# UNITED STATES PATENT AND TRADEMARK OFFICE

APPLICATION NO.	FILING DATE	FIRST NAMED INVENTOR	ATTORNEY DOCKET NO.	CONFIRMATION NO.
10/599,364	05/07/2007	Guy William Pierce	784-117 (196342)	7389
30448	7590	06/07/2010	EXAMINER	
AKERMAN SENTERFITT P.O. BOX 3188 WEST PALM BEACH, FL 33402-3188			HICKS, ROBERT J	
			ART UNIT	PAPER NUMBER
			3781	
			NOTIFICATION DATE	DELIVERY MODE
			06/07/2010	ELECTRONIC

<b>Office Action Summary</b>	<b>Application No.</b> 10/599,364	<b>Applicant(s)</b> PIERCE ET AL.	
	<b>Examiner</b> ROBERT J. HICKS	<b>Art Unit</b> 3781

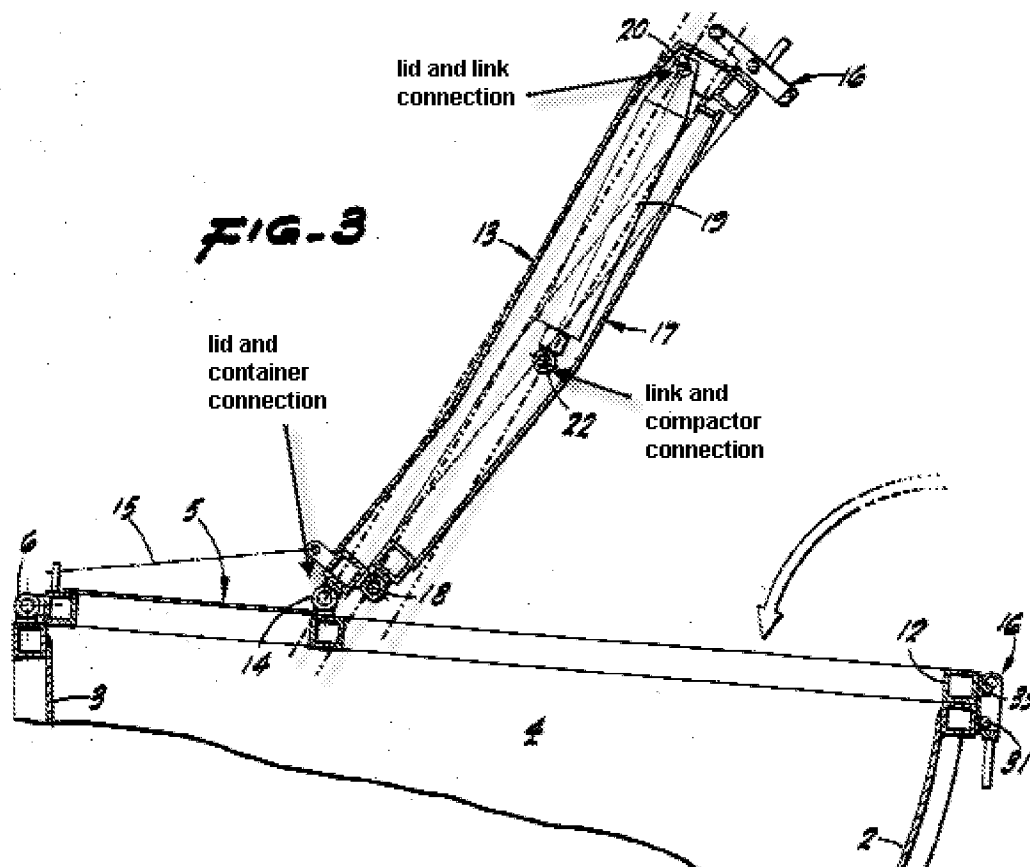
12. Claim 12 is rejected under 35 U.S.C. 102(b) as being anticipated by Schmidt (3,961,573).

The patent to Schmidt – a refuse container with compactor – discloses A compacting lid assembly [Fig. 1] including a rim [12] adapted to interengage with an opening of a bin, [1] an upper lid element [13] arranged to close the opening to the bin

[Fig. 1], a lower compacting element [17] adapted to compact the contents of the bin, the upper and lower elements both being pivotally connected to the rim at respective first ends [14 and 18], such that the pivot points are at least vertically spaced apart; a link [19], the first end of which is pivotally connected to a second end of the compacting element [at 22], the second end of the link being pivotally connected to the lid at a point [20] that remains between the pivot point for the first end of the connecting element and the pivot point of the lid throughout the arc of the lids travel [Figs. 1 and 3]. The pivot point of the link and lid connection is on a plane that is between the planes of the pivot point of the lid to the container and the pivot point of the link to the compactor [Schmidt, Fig. 1].
